Piper Aircraft, Inc.
2926 Piper Drive
Vero Beach, Florida, U.S.A. 32960

SERVICE NO. 1125 LETTER

STALL HORN BRACKET REPLACEMENT

Figure 1
STALL WARNING HORN INSTALLATION (Typical)

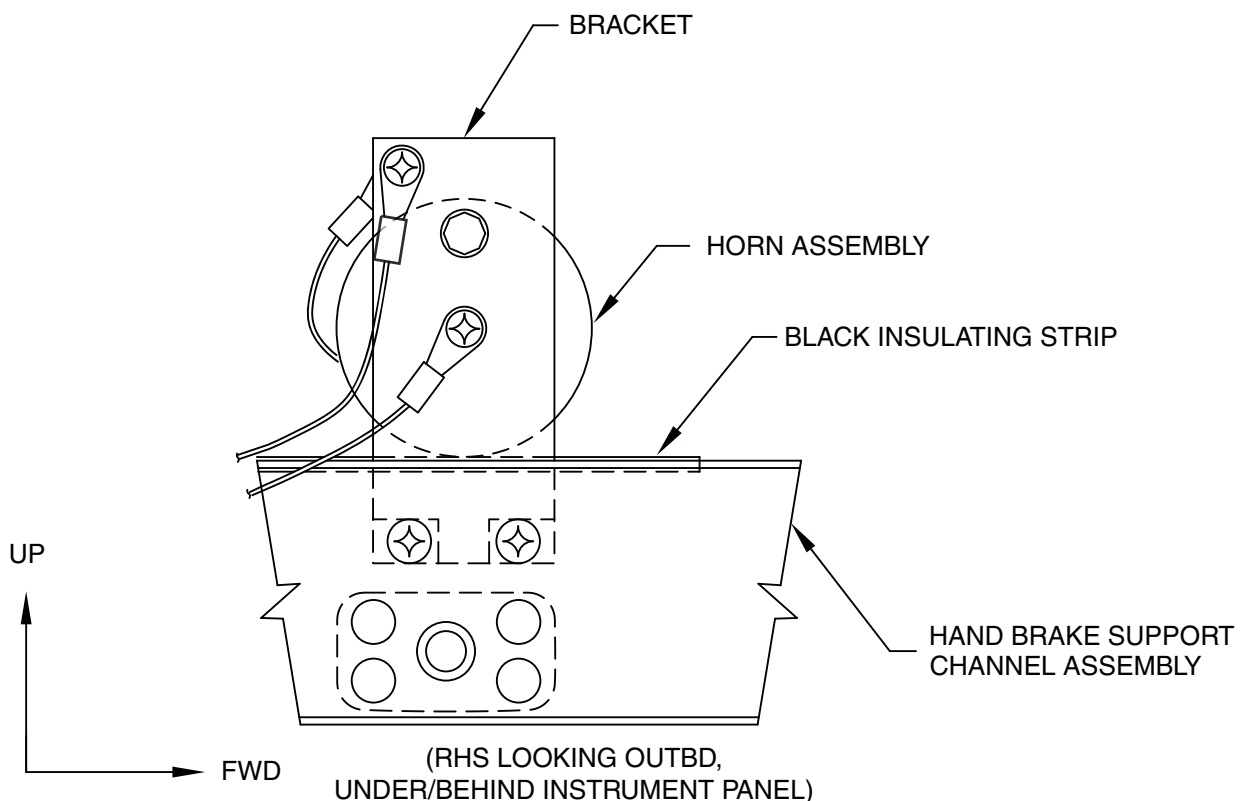
Under certain conditions, the body of the stall warning horn may contact the hand brake support channel assembly, creating an electrical short circuit, which will trip the circuit breaker and render the stall warning alarm inoperable.

For aircraft operators that experience the stall warning circuit breaker tripping unexpectedly, a likely cause of this condition may be that the horn assembly is making intermittent contact with the hand brake support channel assembly. Proceed as follows to verify this condition:

1. Remove electrical power from the aircraft.
2. Locate the stall warning horn assembly, which is mounted on the hand brake support channel assembly, midway between the firewall and the instrument panel as shown in Figure 1.
3. The Bracket 35203-002 is made from phenolic, and is somewhat flexible. Apply gentle hand pressure on the horn assembly, in the direction to allow the horn assembly to contact the flange of the hand brake support channel assembly.
4. Examine the area of contact. There is a black plastic insulating strip mounted on the flange of the hand brake support channel assembly. If the insulating strip does not prevent contact between the horn assembly and the hand brake support channel assembly, order and install "STALL HORN BRACKET REPLACEMENT KIT", Piper part number 88472-002.
5. Make a logbook entry indicating compliance with this Service Letter.

This Service Letter provides troubleshooting information to identify the condition described. For aircraft affected, this Service Letter also announces a kit, which, when installed will provide additional clearance between the stall warning horn and adjacent airframe structure.

MATERIAL REQUIRED: One (1) each, Stall Horn Bracket Replacement Kit, Piper part number 88472-002, per aircraft, on condition.
